Rancho Buena Vista High School – Track and Field Replacement

ADDENDUM 01-LLB

December 9, 2025

PRE-BID RFIS

PRE-BID RFI #3
SAWCUT, GRIND AND
OVERLAY DETAIL
SCALE: NTS

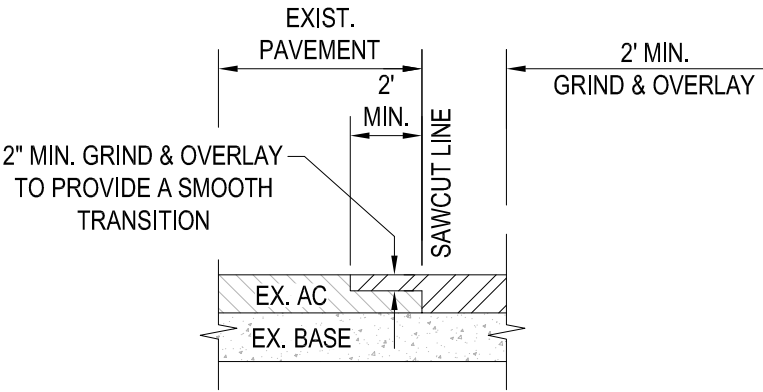
Answer: New fencing shall occur as noted on A-103. Refer to details 11 & 14/A-105 for location of new fencing in relation to the retaining wall.
- RFI #3. Question: Please provide grind & overlay detail per Sheet C-101 Note 10.

Answer: Please see Attachment #1 for sawcut, grind and overlay detail.
- RFI #4. Question: Please provide electrical plans and specifications for the installation of the new light pole per Note 25 on Sheet A-101.

1 ENLARGED SITE PLAN
SCALE: 1"=20'-0"

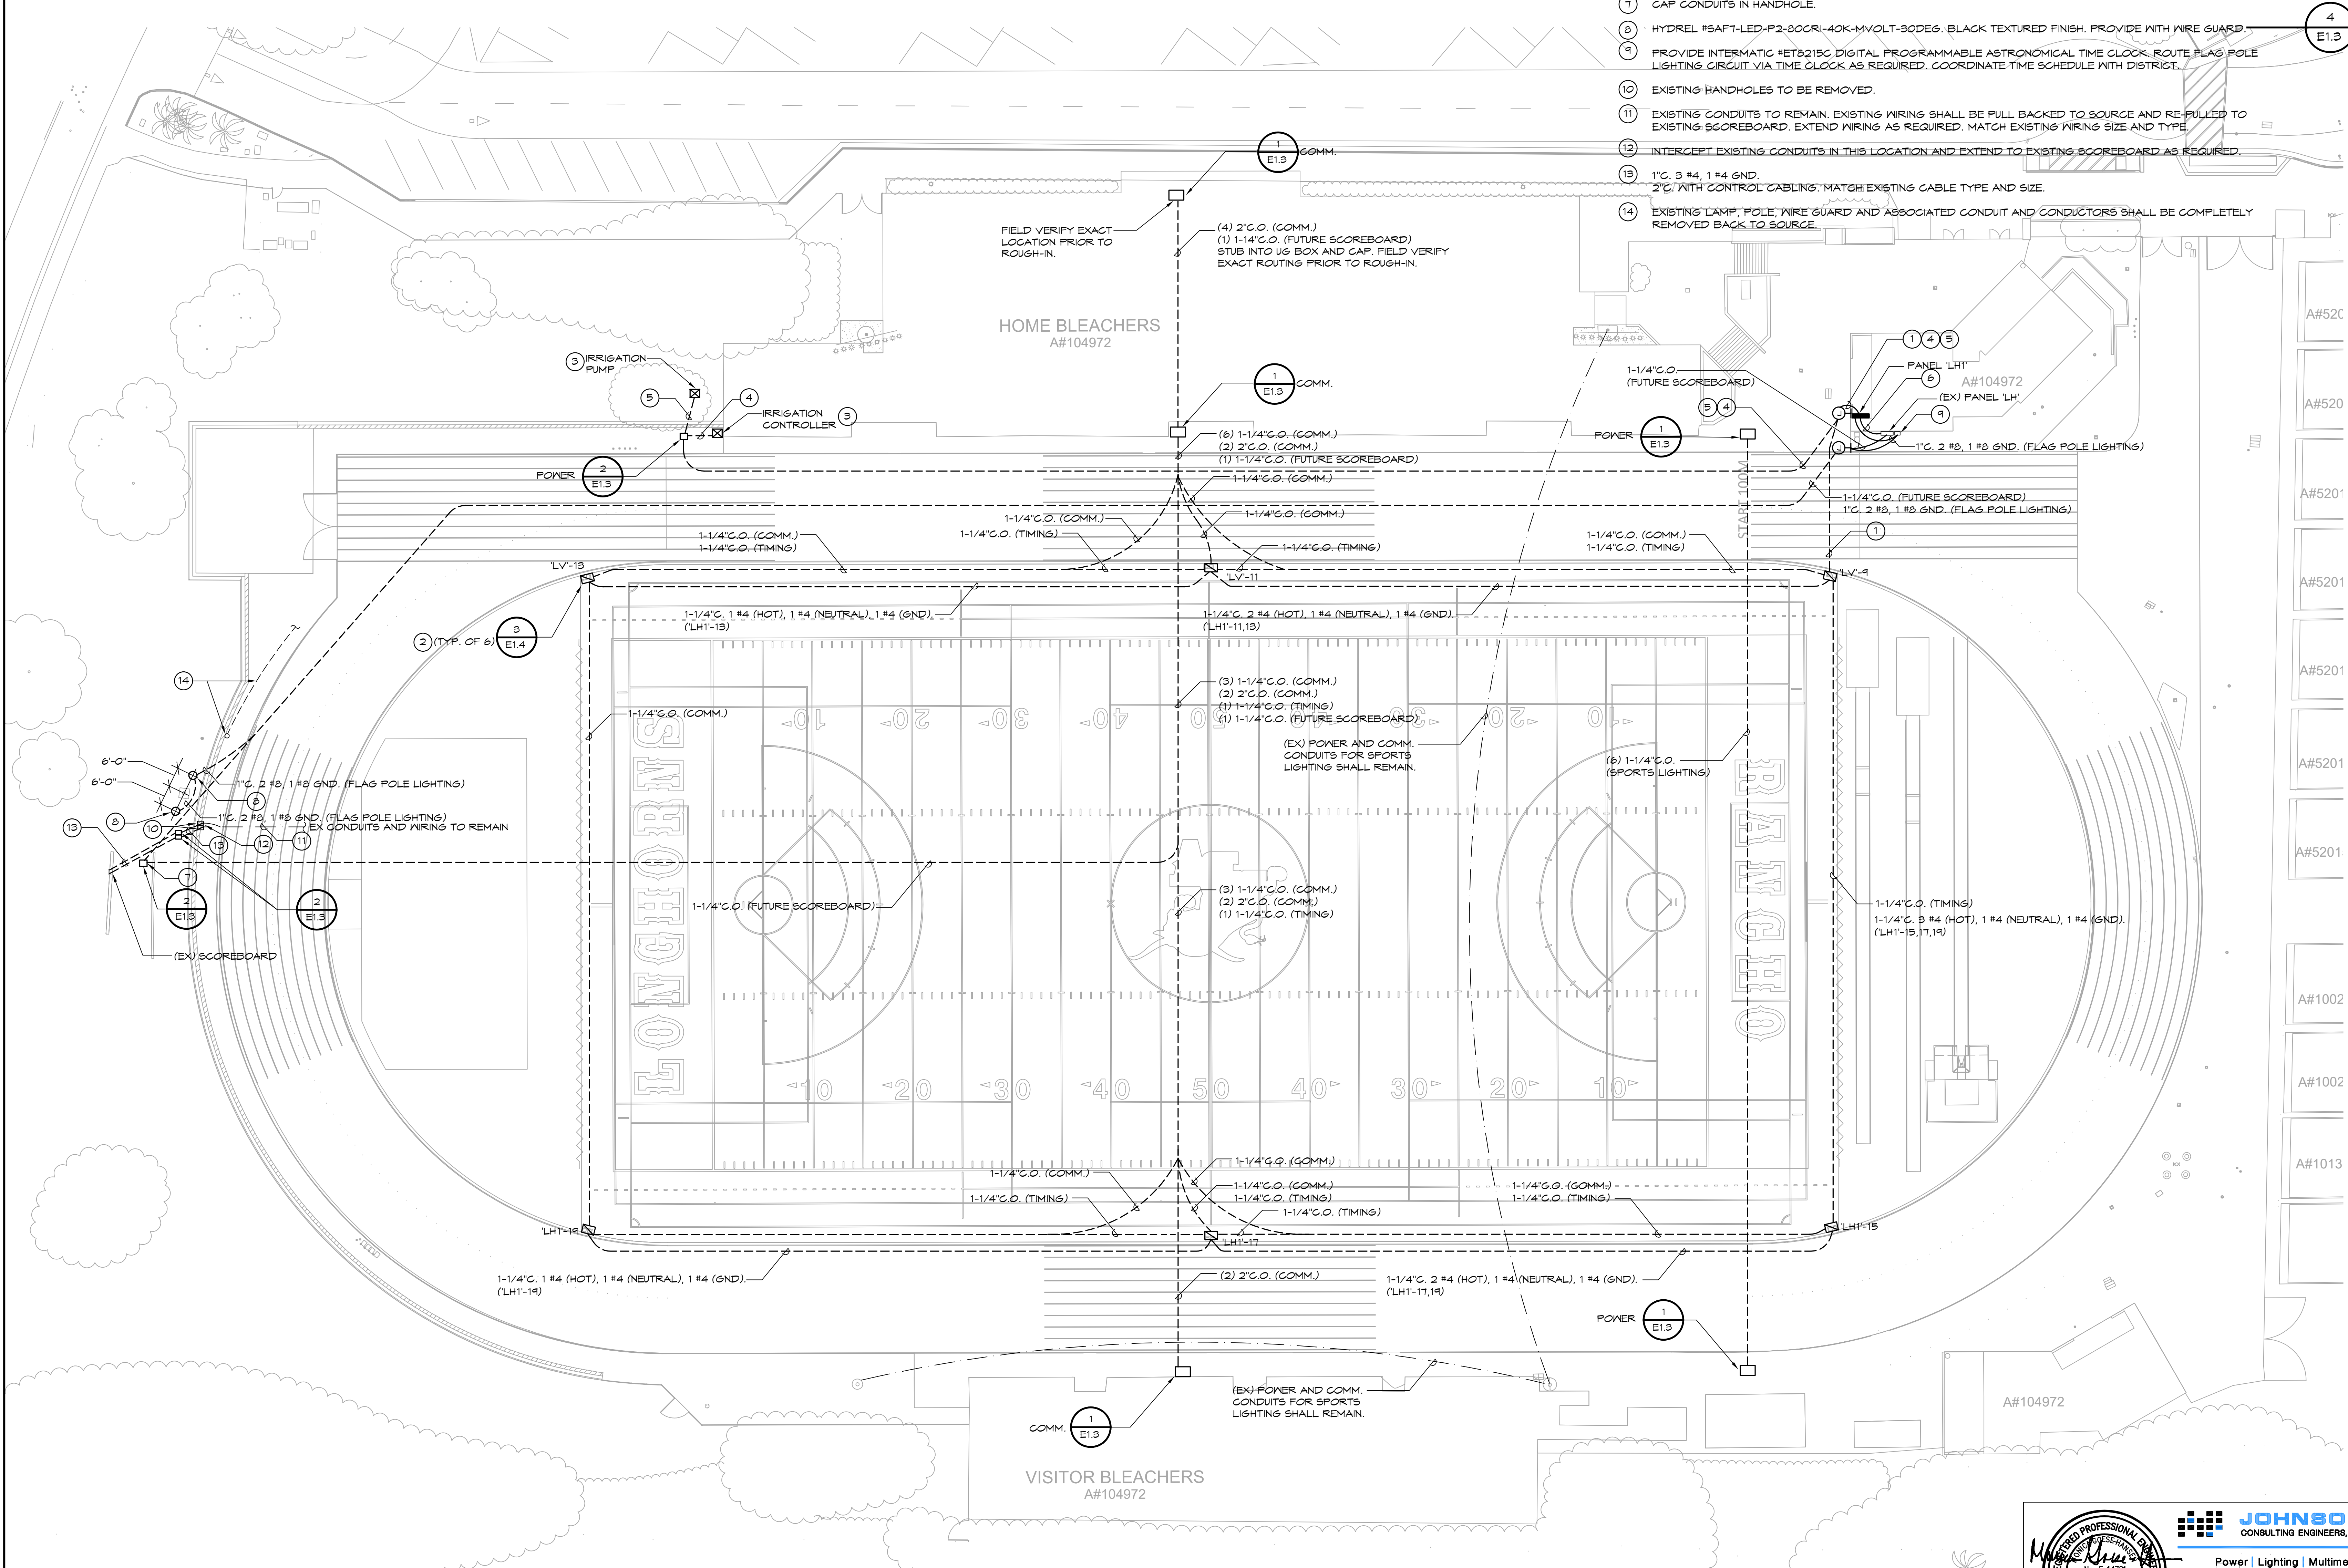
RFI #22. Question: At the northwest corner of the track, Note 19 on Sheet A-102 and Note 25 on Sheet A-101 calls for the demolition of existing light pole. It was observed on the 12/2/25 job walk that there is a flagpole and a light pole at this location. Please clarify the demolition intention.

Answer: Flagpole shall remain in place during construction. Light pole and all related appurtenances shall be removed as noted in electrical drawings. Please see Attachment #3, DSA Approved Addendum 01.

- 14 EXISTING LAMP, POLE, WIRE GUARD AND ASSOCIATED CONDUIT AND CONDUCTORS SHALL BE COMPLETELY REMOVED BACK TO SOURCE.
